# Environmental and Ecological Planning Advisory Committee

12th Meeting of the Environmental and Ecological Planning Advisory Committee  
November 15, 2018  
Committee Rooms #1 and #2

6019 HAMLIN STREET sub division, EIS by Natural Resources Solutions, Inc., dated August 2018, received by EEPAC on October 18, 2018

## Preliminary Comments on Stantec EIS for Clarke Road Improvements

Patch 10075a

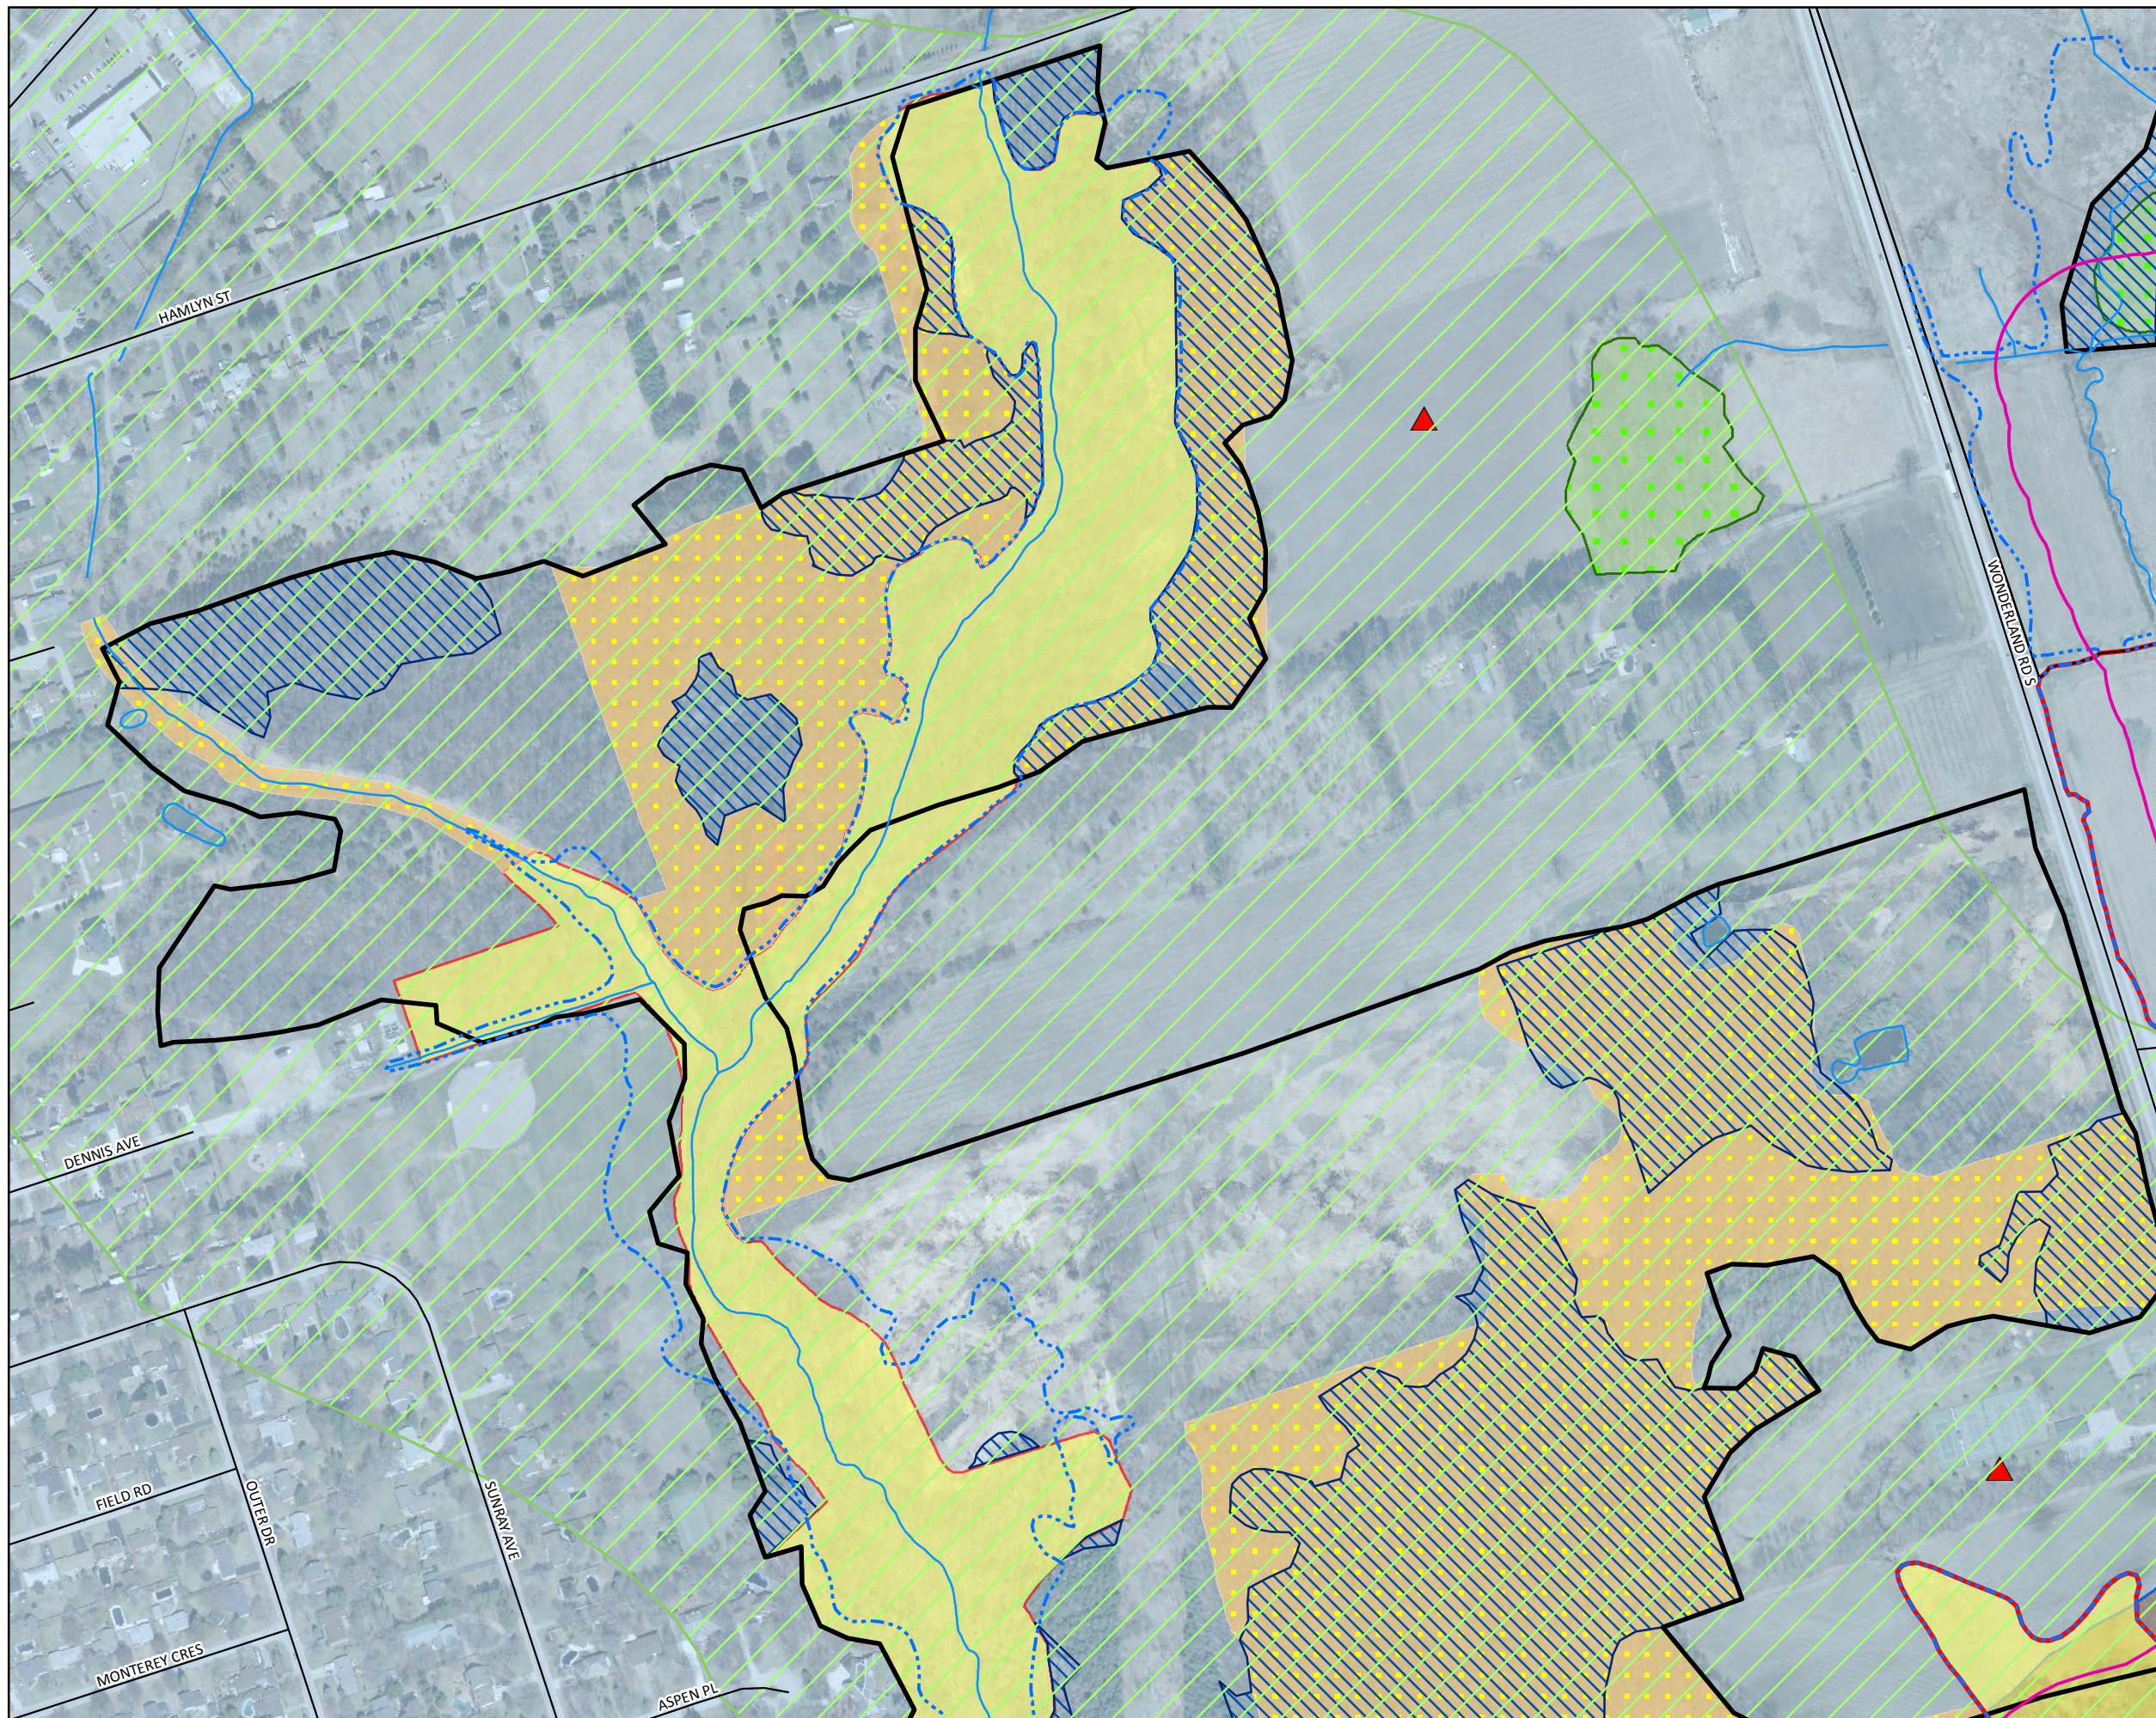
**RECOMMENDATION: The minimum buffer from the wetland must be 30 m and 10 m from woodland features. This must be put in place for the entire patch which constitutes the East Lambeth Forest ESA (see attached pages from the SWAP Natural Heritage Study)**
